can-am
**WARRANTY
CAMPAIGN**
**ROADSTER
WARRANTY
Bulletin**

Campaign no.: 2011-0016
2012-0006

Subject: **TO BE PERFORMED AT PDI ON
UNREGISTERED (UNSOLD) VEHICLES**
**1- Updated Throttle Body Actuator
Protection**
2- ECM and TCM Software Updates
**3- Middle Side Panel Grommet
Replacement (2011 Models Only)**

No. **2012-8**
REVISION 1
January 23, 2014

rbg2012-005-002

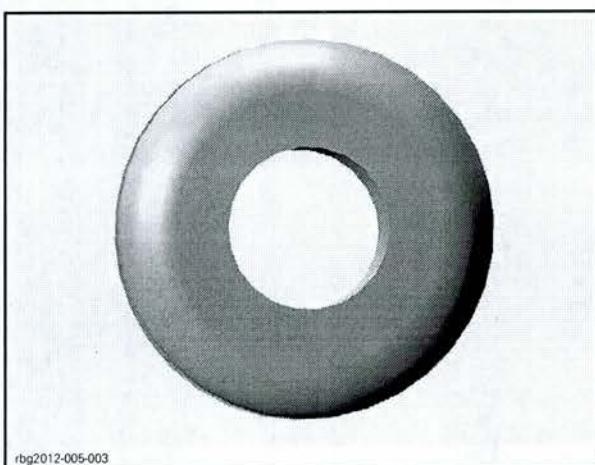
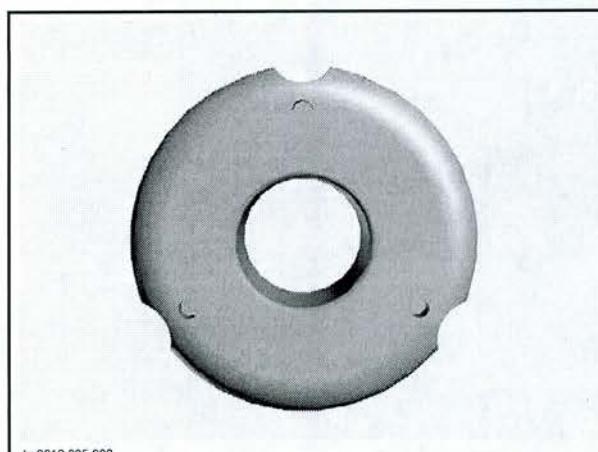
On some 2011 vehicles, on which 2011-8 OR 2011-13 WARRANTY CAMPAIGNS has not been performed, one of the middle side panels rubber grommets might fall off after multiple removal and installation of the panel.

2. Identify grommet type.

NEW TYPE - NOTCHES ON THE OUTER EDGE AND MOLDED STEEL WASHER

OLD TYPE - SMOOTH OUTER EDGE

GROMMET TYPE	ACTION
Old Grommet type	Replace by (P/N 705 003 264)
New Grommet type	No action required

3. If required, remove the grommet using a flat screwdriver.
4. Scrape off any remaining grommet and glue residue from area where grommet was glued.
5. Install the new grommet.
6. Repeat steps on the other side of the vehicle.
